Subject: Former Mabardy Landfill, Winchendon, MA
Request to Amend the Order of Conditions
MassDEP File No. 345-0675
CEC Project 306-000

On behalf of 580 River Street LLC (the Applicant), Civil & Environmental Consultants, Inc. (CEC) is pleased to submit this Request to Amend the Order of Conditions (MassDEP File # 345-0675) with supporting information for the final closure of the former Mabardy Landfill located on River Street (Map 17 - Lot 42 and Map 17 – Lot 41) in Winchendon, Massachusetts (Site). This Request to Amend the Order of Conditions is submitted in accordance with the Massachusetts Wetlands Program Policy 85-4: Amended Orders and in accordance with Condition numbers 14 and 29 from the Order of Conditions that was issued for the project.

The Applicant submits this Request to Amend the Order of Conditions to incorporate modifications to the north stormwater basin design based on test pits performed upon commencement of the site work which revealed existing groundwater conditions were different than originally assumed in the design. Condition number 27 of the Order of Conditions that was issued for the project required that test pit investigations be performed within th

DRAINAGE AREAS MAP

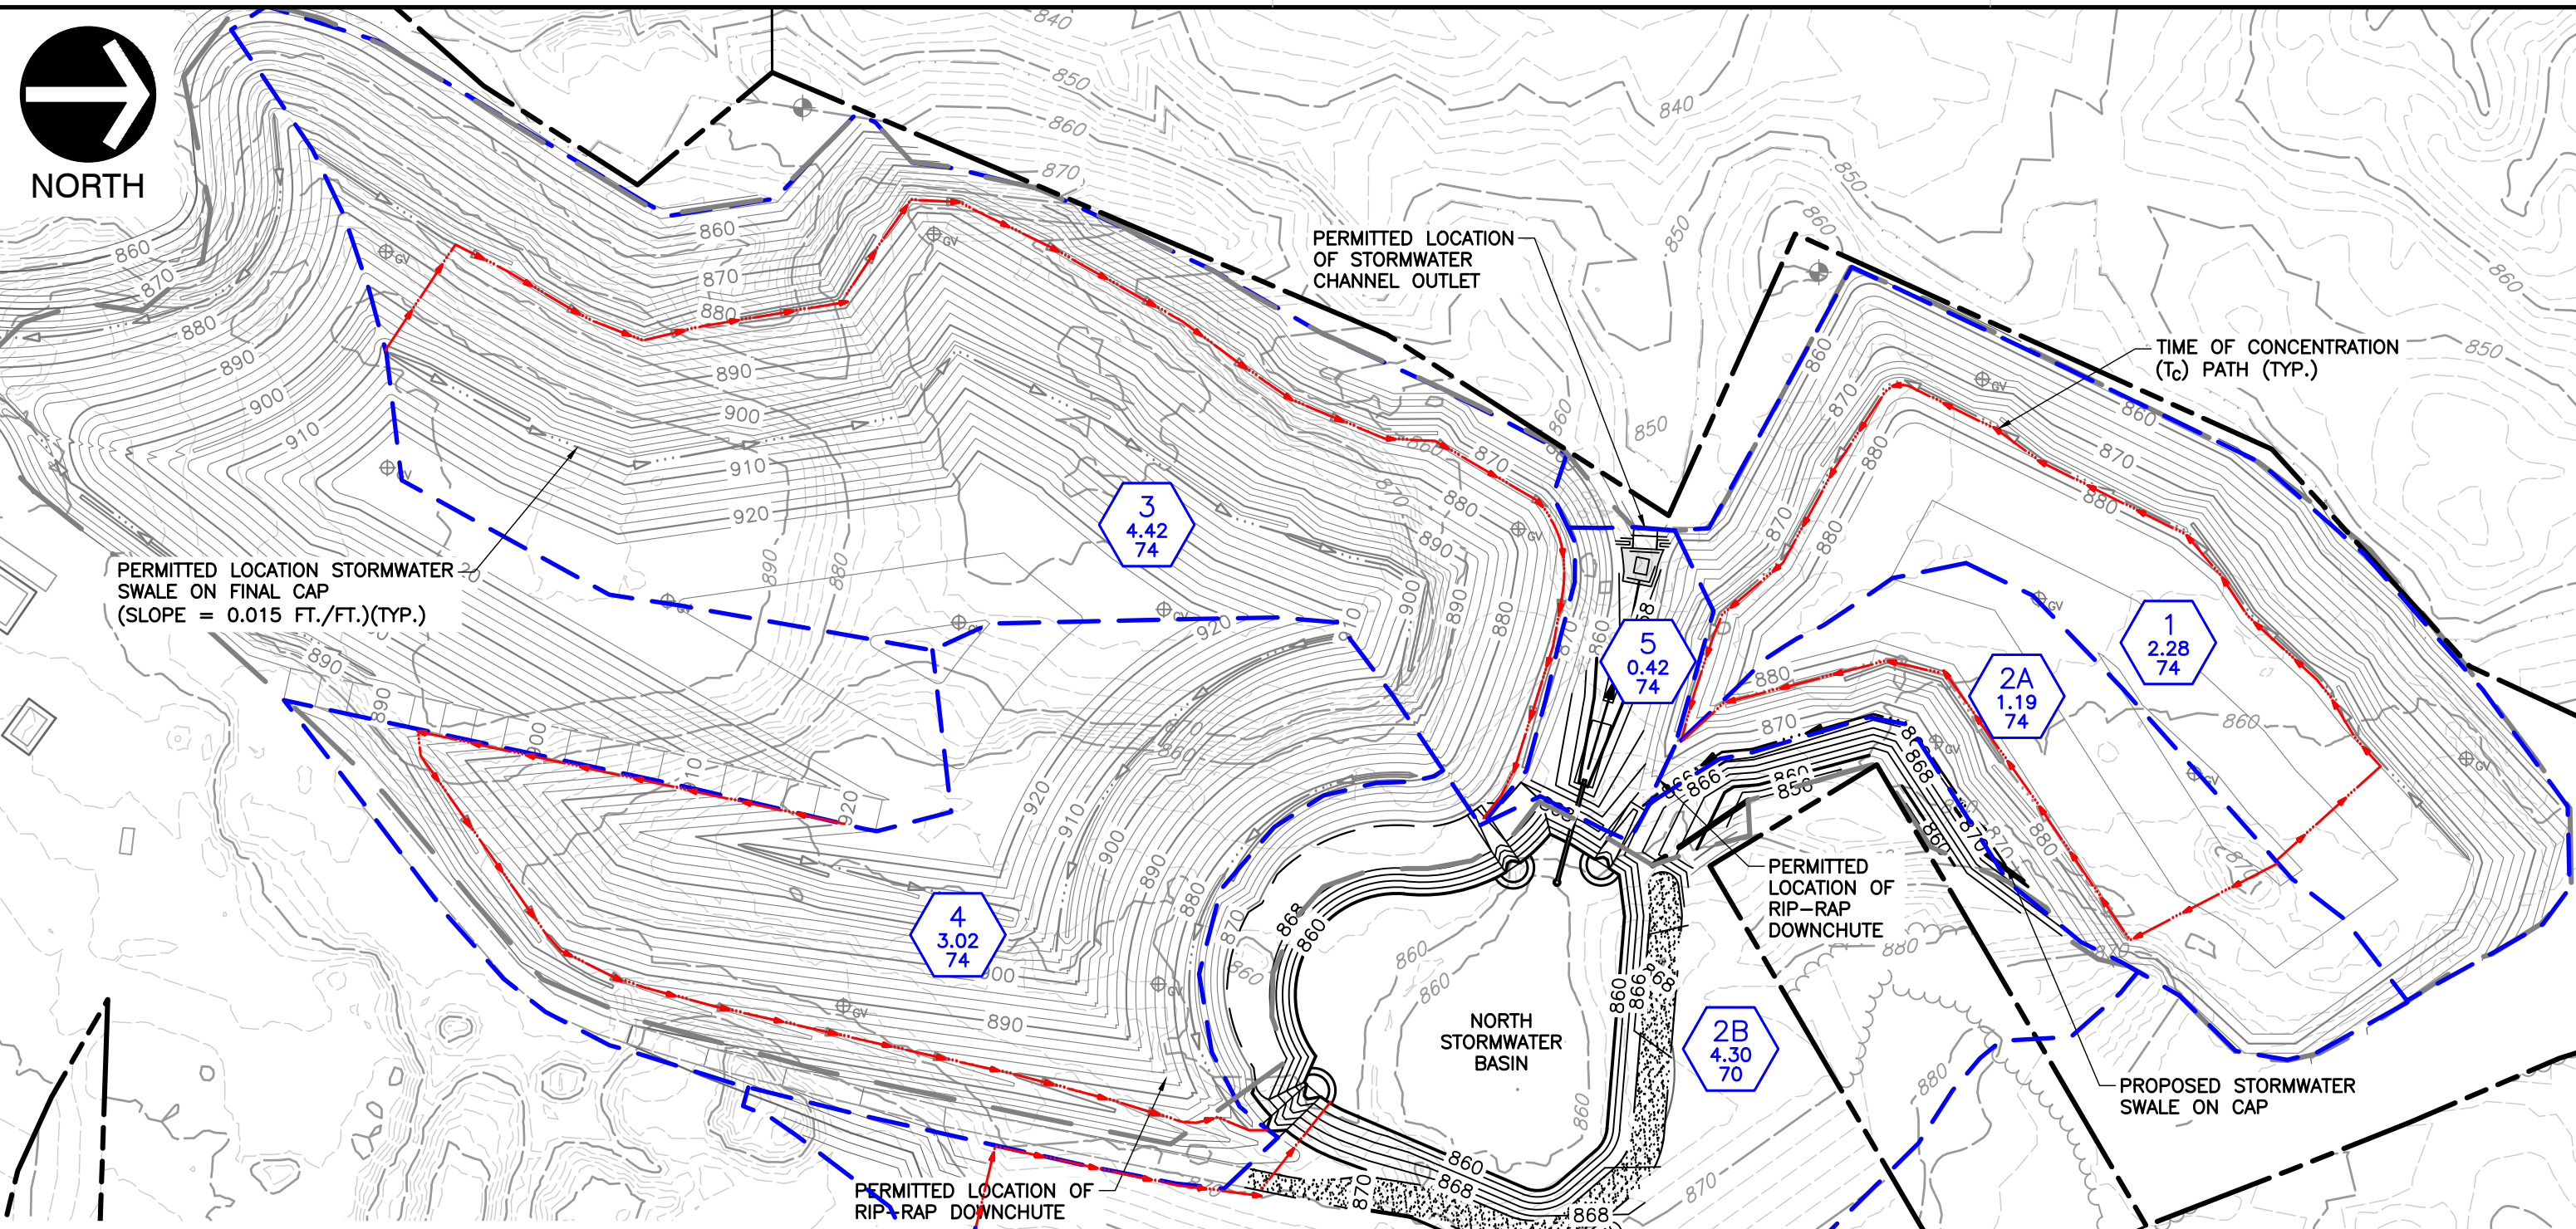
PROPOSED STORMWATER SWALE ON CAP

**SUBGRADE ELEVATIONS
 NORTH BASIN MODIFICATIONS**
 DRAWING NO. **C300**
 SHEET 3 OF 5

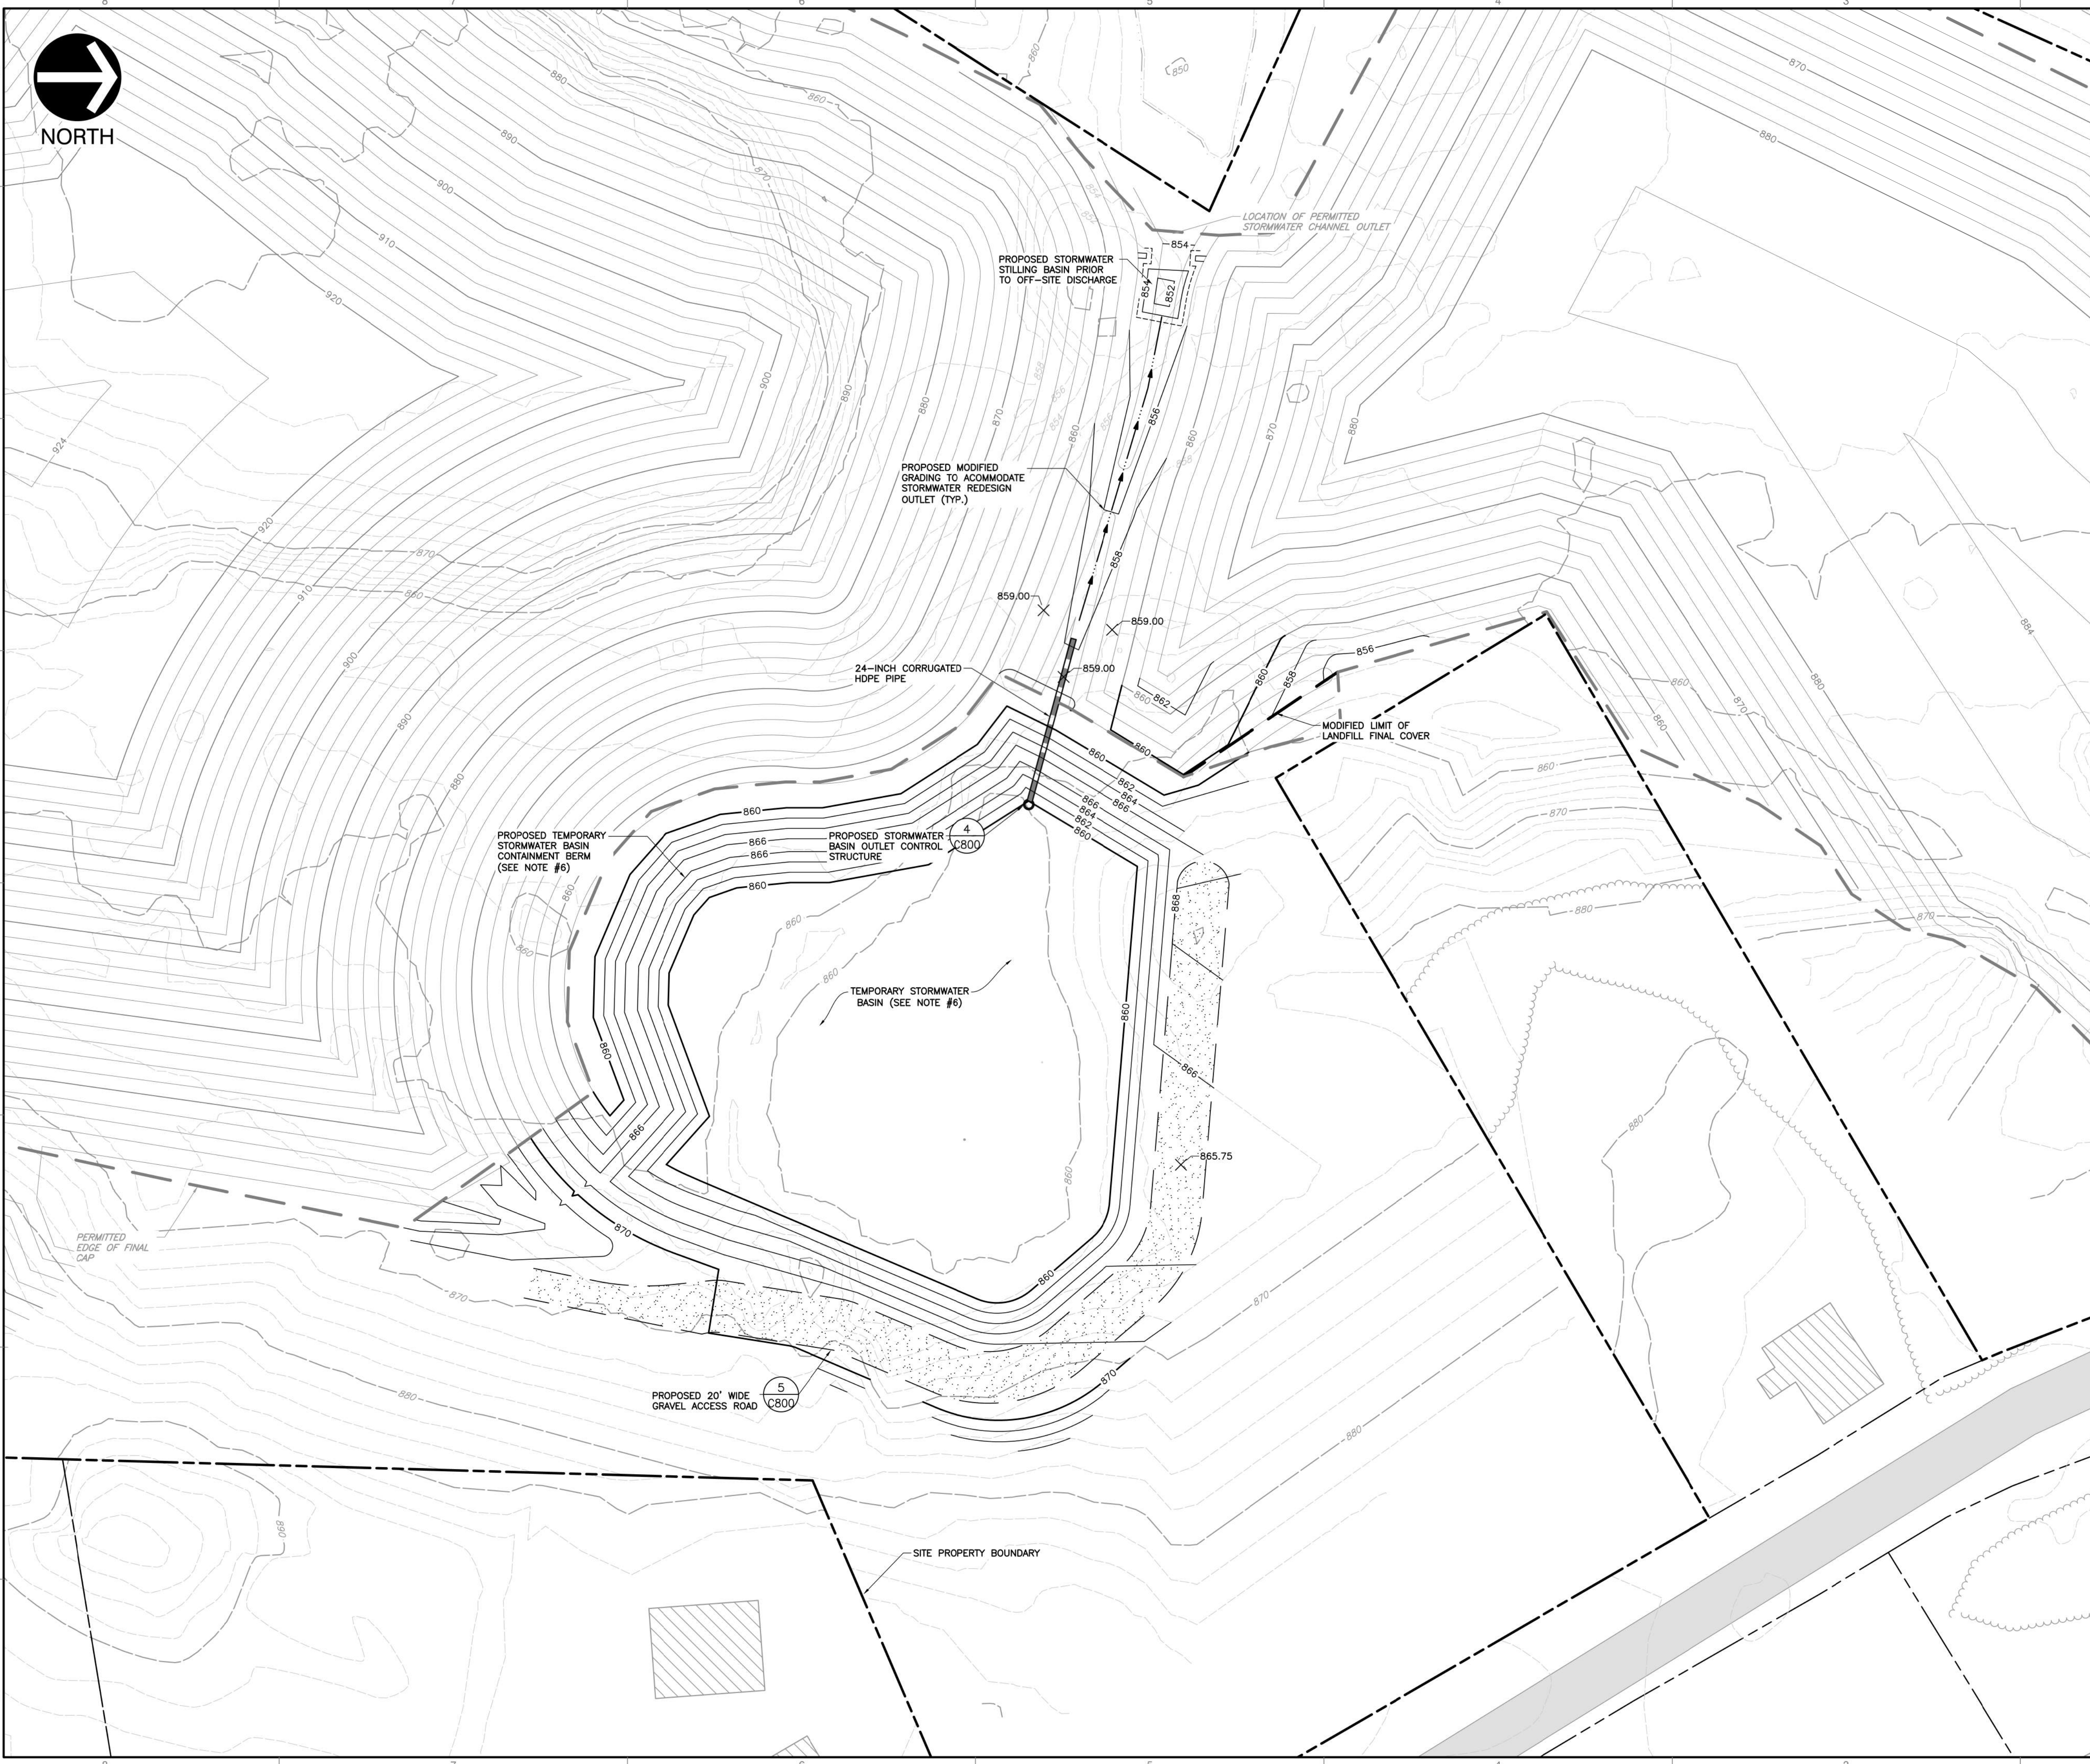
The proposed modifications involve altering the layout and grading of the north basin. In order to provide the minimum separation of 2 feet to the existing groundwater level, the bottom of the north basin has been raised to an elevation of 860 feet, which roughly coincides with the elevation of the existing ground in the area and provides 3 feet of separation to existing groundwater elevations observed during excavation of the December 2020 test pits.

- NO CHANGES ARE PROPOSED TO THE PERMITTED HORIZONTAL EXTENTS OF GRADING AND SHAPING MATERIAL PLACEMENT. MINOR CHANGES IN VERTICAL ELEVATIONS OF GRADING AND SHAPING MATERIAL PLACEMENT IS REQUIRED TO TIE INTO EXISTING ELEVATIONS, AND TO ACCOMMODATE MODIFIED STORMWATER CHANGES FOR THE NORTH BASIN OUTLET CONTROL STRUCTURE.

- PROPOSED GRADES SHOWN FOR TEMPORARY STORMWATER BASIN ARE APPROXIMATE AND FOR REFERENCE ONLY. OUTLET CONTROL STRUCTURE SHOWN IS SAME AS FINAL CONDITIONS, BUT CONTRACTOR MAY PROVIDE SIMILAR STORMWATER BASIN GRADING TO PROVIDE ADEQUATE STORMWATER STORAGE VOLUME BASED ON CURRENT OPERATIONS WITHOUT EXCAVATING BELOW ELEVATION 860 FEET.
